Re: 251334
REUNION AT BLACKWELL/ Bldg D

The truss drawing(s) referenced below have been prepared by MiTek USA, Inc. under my direct supervision based on the parameters provided by Heartland Truss, LLC..

Pages or sheets covered by this seal: I78869129 thru I78869132

Job 251334	Truss A5A	Truss Type Hip	Qty 1	Ply 1	REUNION AT BLACKWELL/ Bldg D	178869129
---------------	--------------	-------------------	----------	----------	------------------------------	-----------

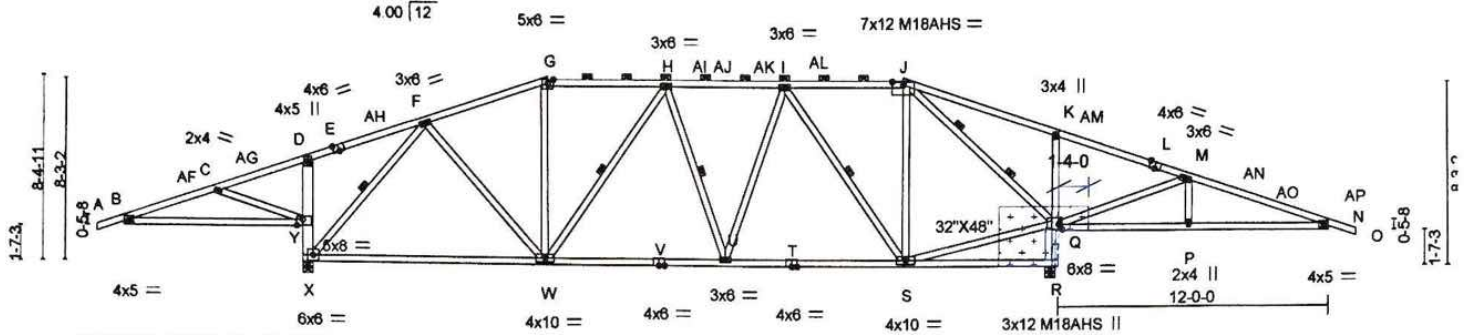
REPAIR
REMOVE 0-1-8 FROM Q-R

LUMBER AND CONNECTOR PLATES (SHOWN DASHED) TO BE CUT CLEANLY AND ACCURATELY AND THE REMAINING PLATE(S) MUST BE FULLY EMBEDDED AND UNDISTURBED. 6x8 PLATE AT JT. Q MUST REMAIN INTACT WITHOUT DISTURBANCE.

ATTACH 7/16" OSB GUSSET (7/16" RATED SHEATHING 24/16 EXP 1) TO EACH FACE OF TRUSS WITH (0.131" X 2.5" MIN.) NAILS PER THE FOLLOWING NAIL SCHEDULE:
2 X 3'S - 2 ROWS, 2 X 4'S - 3 ROWS, 2 X 6'S AND LARGER - 4 ROWS: SPACED @ 4" O.C.
NAILS TO BE DRIVEN FROM BOTH FACES. STAGGER SPACING FROM FRONT TO BACK FACE FOR A NET 2" O.C. SPACING IN EACH COVERED TRUSS MEMBER. USE 2" MEMBER END DISTANCE.

INSTALL 2 X 4 SPF/DF/SP NO 2: CUT TO FIT TIGHT. TRIM CORNER OF NEW MEMBER TO AVOID DAMAGE TO EXISTING CONNECTOR PLATES.

Job	Truss	Truss Type	Qty	Ply	REUNION AT BLACKWELL/ Bldg D	178869130
251334	A6A	Hip	1	1

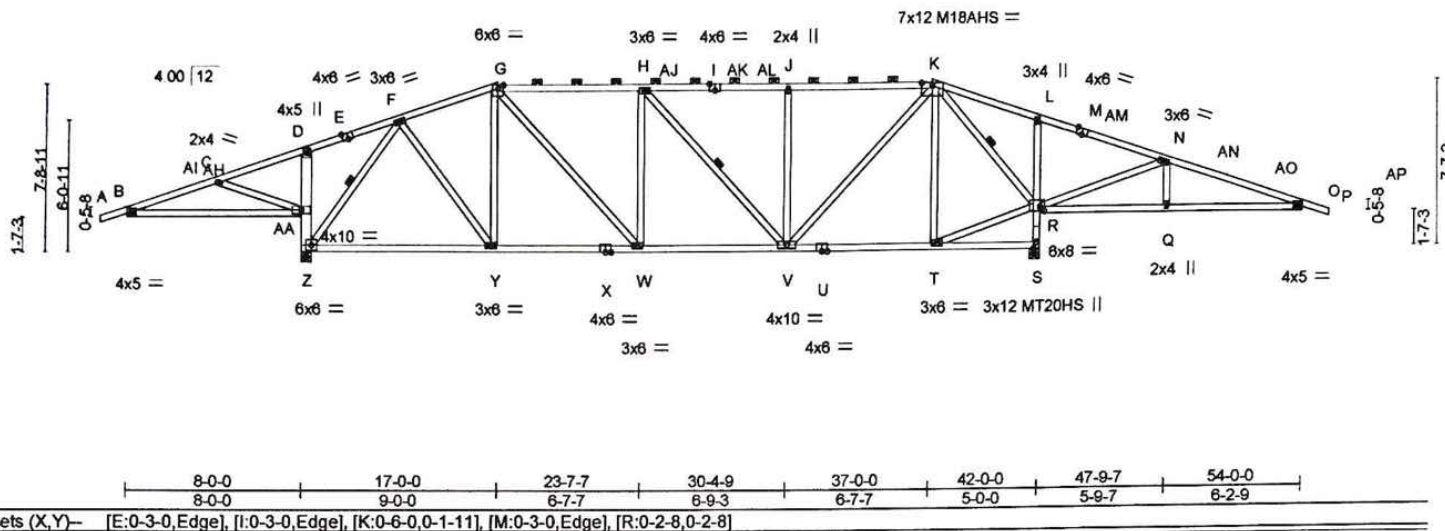
REFER TO MITEK REFERENCE NUMBER I78869129 FOR REPAIR DETAIL

Job	Truss	Truss Type	Qty	Ply	REUNION AT BLACKWELL/ Bldg D	178869131
251334	A7A	Hip	1	1

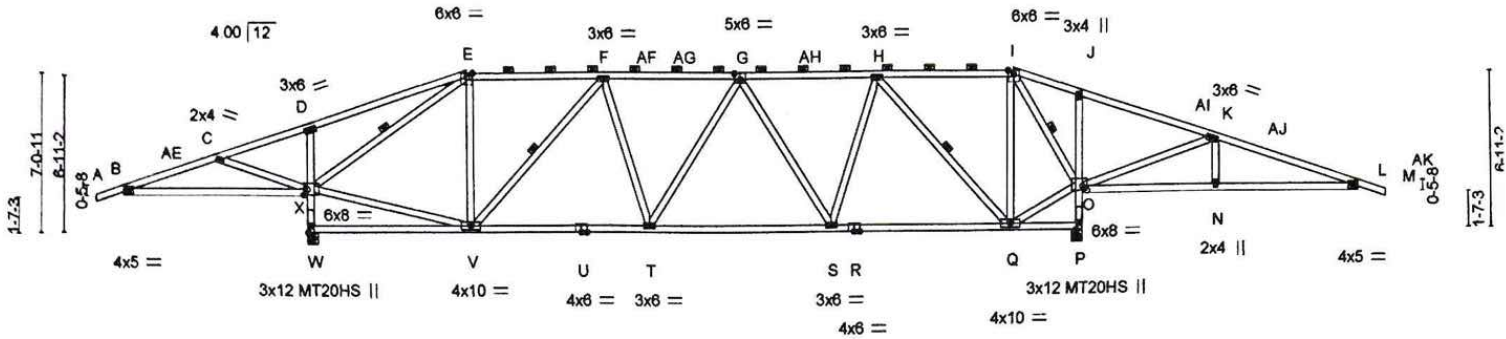
REFER TO MITEK REFERENCE NUMBER I78869129 FOR REPAIR DETAIL

Job	Truss	Truss Type	Qty	Ply	REUNION AT BLACKWELL/ Bldg D	178869132
251334	FL1	Flat Girder	2	2

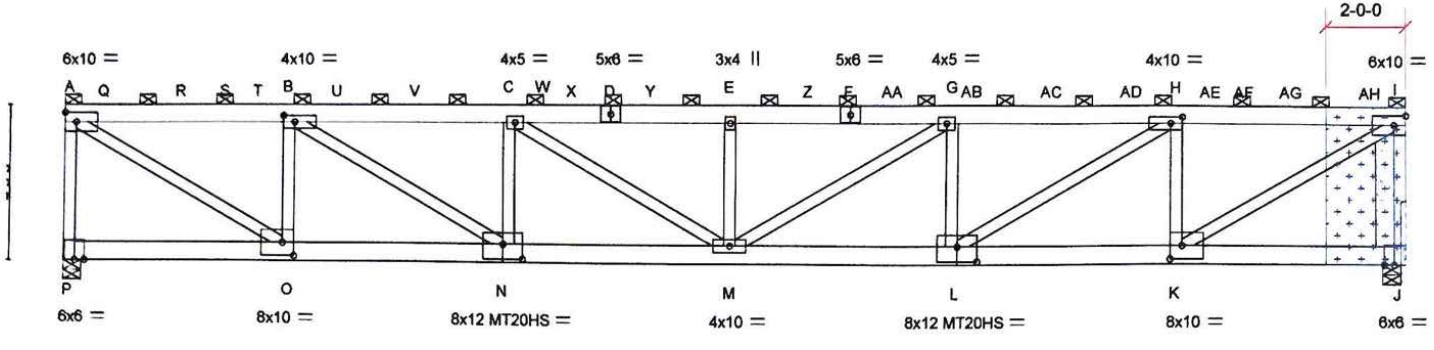
LUMBER AND CONNECTOR PLATES (SHOWN DASHED) TO BE CUT CLEANLY AND ACCURATELY AND THE REMAINING PLATE(S) MUST BE FULLY EMBEDDED AND UNDISTURBED. 6x10 PLATE AT JT. "I" MUST REMAIN INTACT WITHOUT DISTURBANCE. Scale = 1:57.6

REPAIR: REMOVE 0-1-8 BY 1-7-3 SECTION OF RIGHT END VERTICAL STARTING AT JOINT J (ONE-PLY)

ATTACH < 2 LAYERS > 3/4" PLYWOOD OR OSB GUSSET (23/32" RATED SHEATHING 48/24 EXP 1) TO EACH FACE OF TRUSS WITH (0.131" X 3.0") NAILS PER THE FOLLOWING NAIL SCHEDULE: 2 X 4'S - 3 ROWS, 2 X 6'S AND LARGER - 4 ROWS: SPACED @ 2" O.C. USE 2" MEMBER END DISTANCE. GLUE PLYWOOD LAYERS TOGETHER PRIOR TO ATTACHING TO TRUSS.

INSTALL (2 PLY) 2 X 6 SPF/DF/SP NO.2 CUT TO FIT TIGHT. ATTACH PLYS WITH TWO ROWS OF (0.131" X 3") NAILS SPACED 9" O.C TRIM CORNER OF NEW MEMBER TO AVOID DAMAGE TO EXISTING CONNECTOR PLATES.
